## 4.0 COMMENTS ON THE DRAFT EIR AND RESPONSES TO COMMENTS

### 4.1 INDEX TO COMMENTS

The City of Berkeley appreciates the opportunity to comment on the Draft Environmental Impact Report (DEIR) for the Computational Research and Theory Facility (CRT). Our comments relate to the City's major areas of concern as follows:

FIGURE 4.0-2

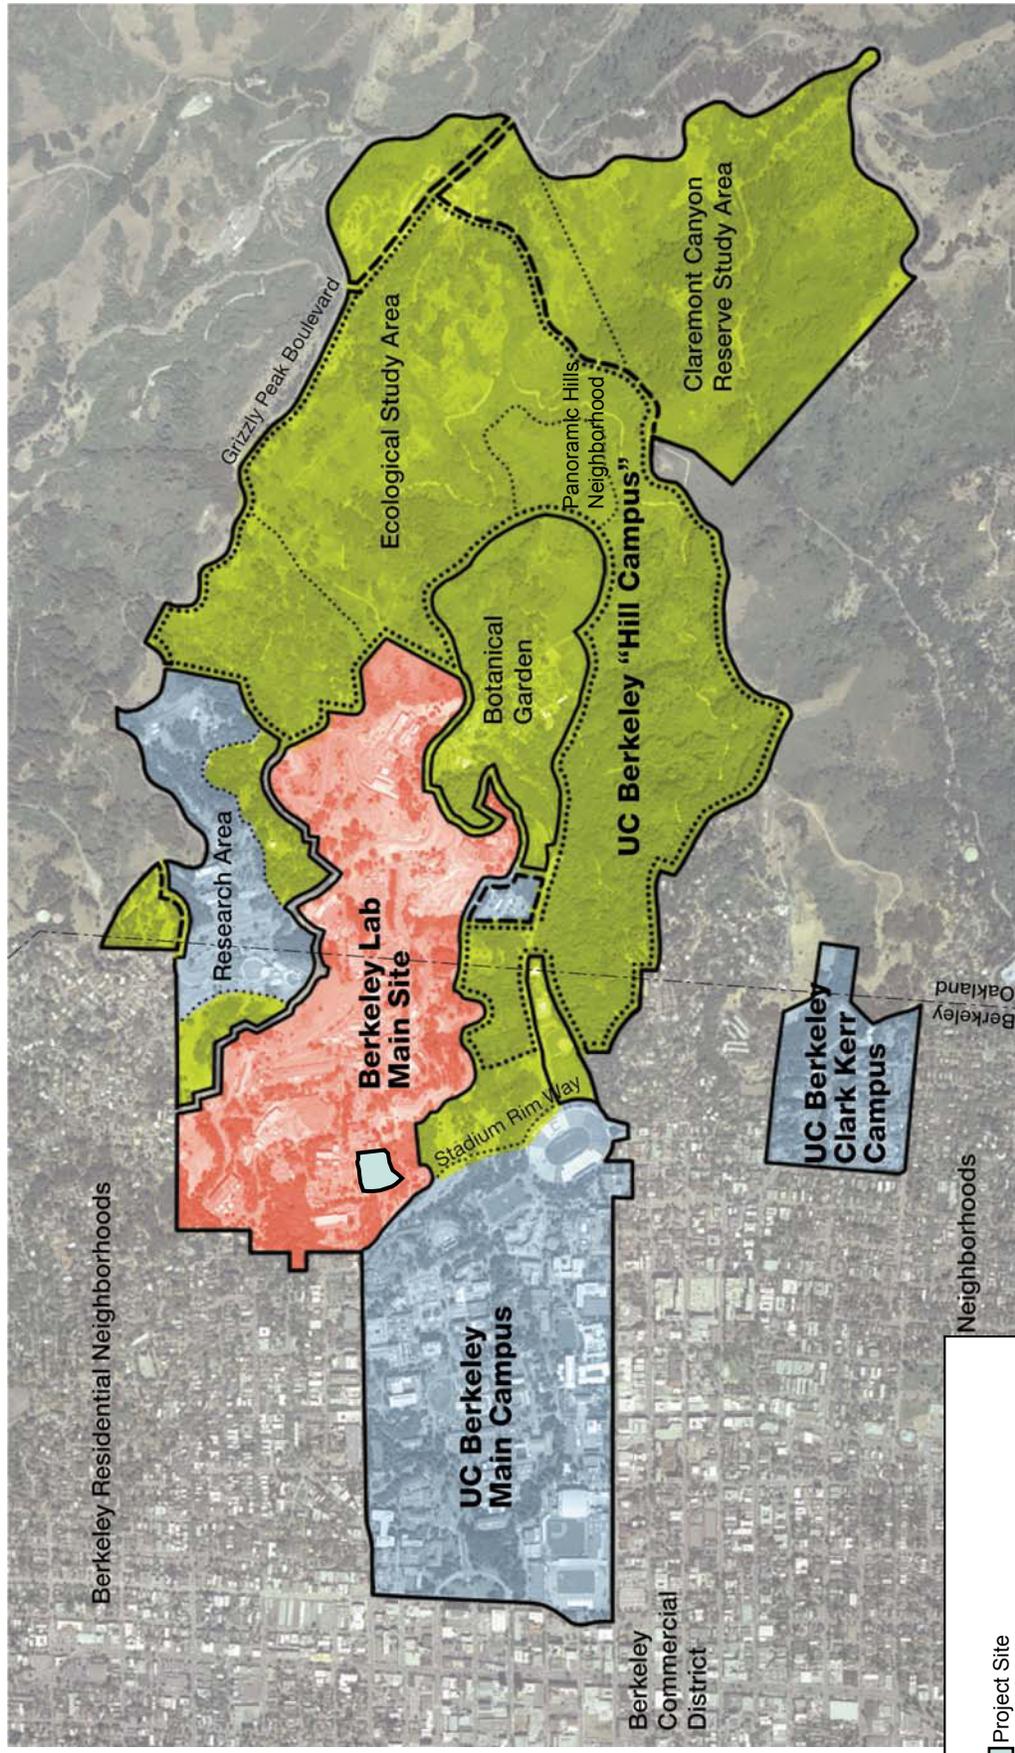
Photo 4 on the **Figure 4.0-2, Additional Site Photos**, (shown at the end of **Section 4.0**), of this Final EIR depicts the requested view from Oakland at Broadway near Highway 13. As shown in this view, the intervening ridge between Claremont Avenue and Highway 24 completely screens views of the project site and the LBNL campus from this location. Other views from the south are depicted in photos 1 through 3 on this figure.

**Figure 4.0-2**, (shown at the end of **Section 4.0**), in this Final EIR includes views from the south of the site, including three from locations along Telegraph Avenue. Photo 1, taken from the corner of Haste and Telegraph, shows a view that includes portions of Building 50 and the LBNL campus. However, from this location the laboratory buildings appear small and do not dominate the view. (See also **Response to Comment PH-9**). As shown in Photo 2 from Telegraph Avenue at Oregon Street, some views of the project site are also available further south on Telegraph where the street widens. The LBNL campus buildings appear even smaller in relationship to the entire view. In other locations, such as at Ashby and Telegraph Avenues, existing buildings and vegetation screen views toward the site.
